Access Assessment Report

12 Boyle Street & 307 Sydney Road, Balgowlah

Date: 30th June 2022

Report no. J1069-Access-2

Figure 2: Markup of existing dwelling adaptable bedroom

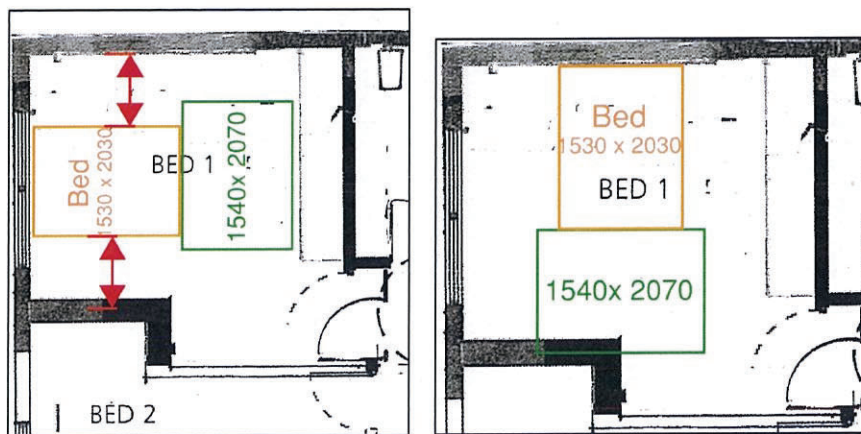
The adaptable bedroom of the existing dwelling does not appear large enough to accommodate the required circulation space. Adjustment to the existing wall between Bed 1 & Bed 2 may be required. Compliance to be detailed in the construction stage plans. The figures below show how the circulation space overlaps the existing wall in the two different bed orientations.
